TITLE: Blue Shield		REV: 1.0
EasyEDA	Company: Digital Nomade	Sheet: 1/1
	Date: 2022-09-16	Drawn By: fcolmant

V1.01

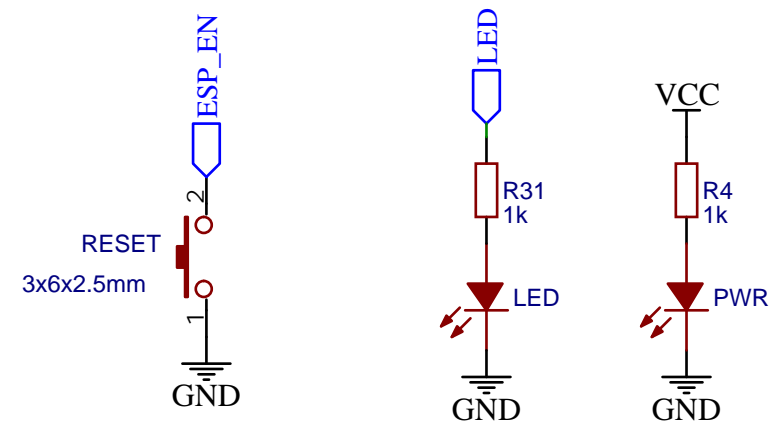
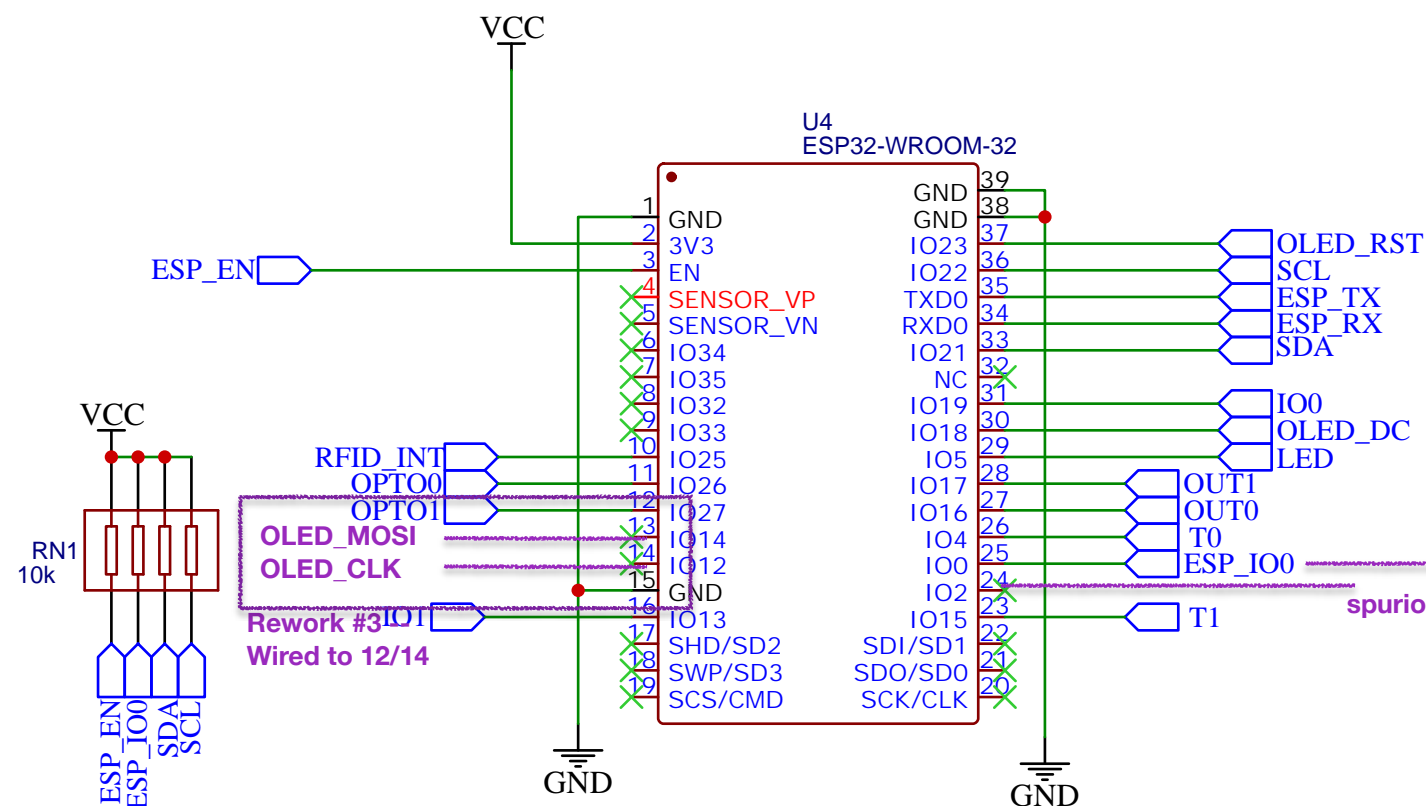
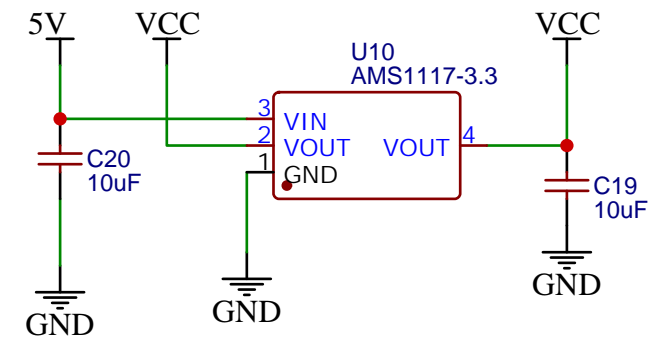
Label turns overlaps rfid logo back
add version # to board
add out labels both sides of board
testpins for rx/tx/io0/en
chjcek drive LEDs on ground
higher speed serial a problem

rework #4 - wired to OLED_CS

spurious pulses once wifi comes on

- power led added
- tx/rx swapped
- led moved to digital ctrl
- touch to pin 15 (was 0
- fix dual 5V nets

TITLE: Sheet_1		REV: 1.0
嘉立创EDA	Company: Your Company	Sheet: 1/1
	Date: 2023-01-10	Drawn By: dirkx

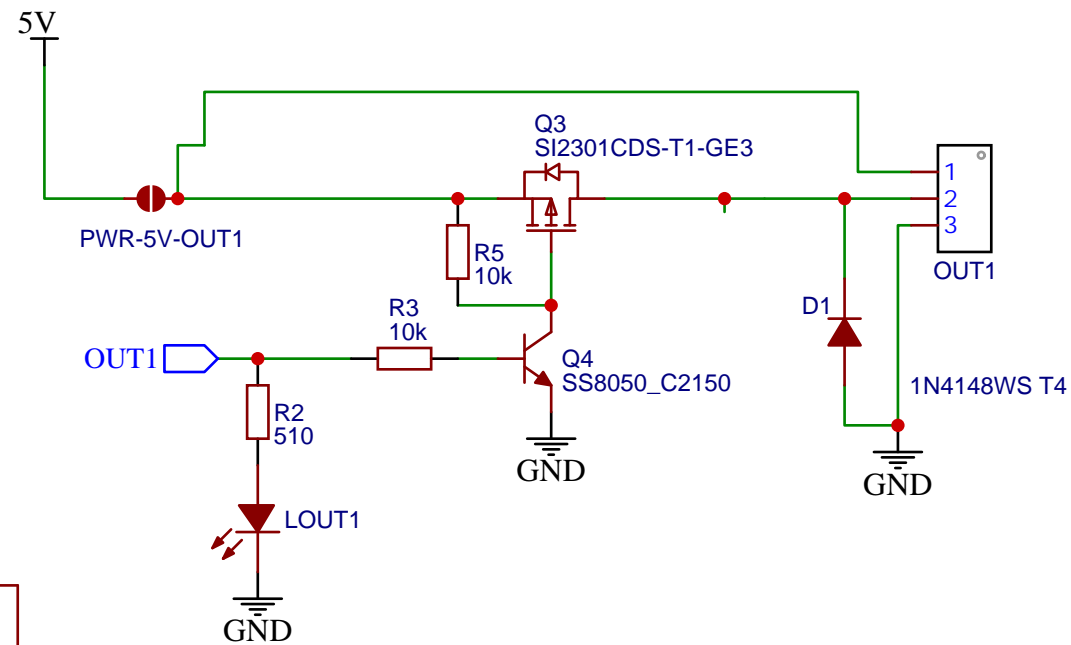
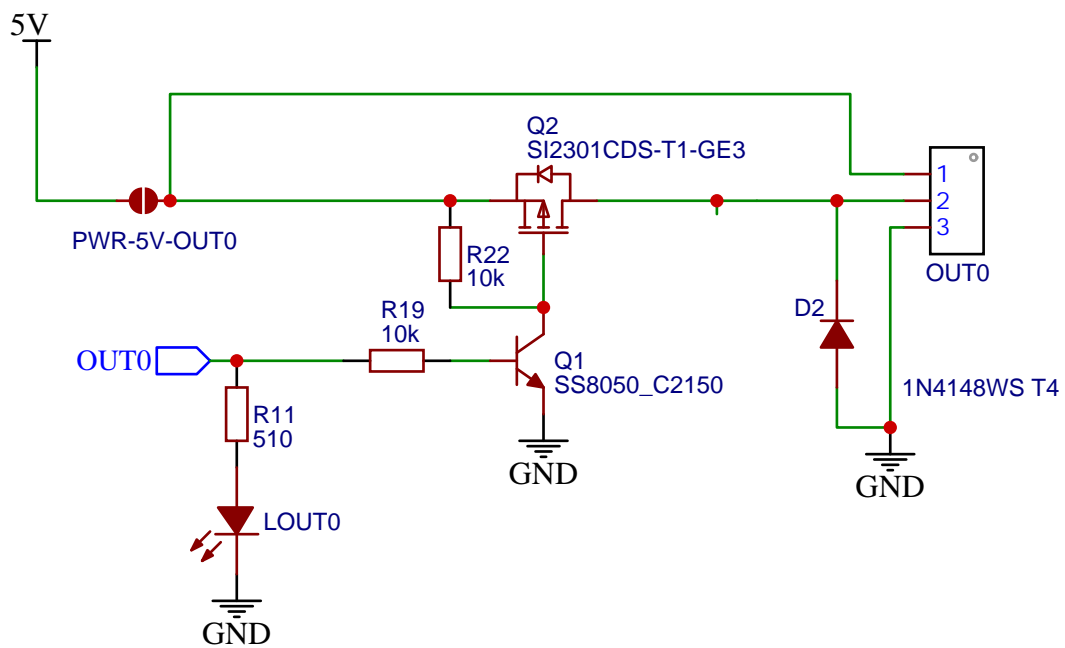
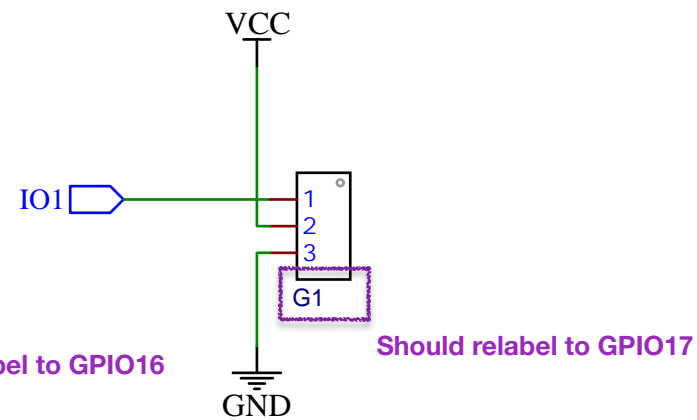
Replace by internal TOUCH numbers ? 0/3 ?
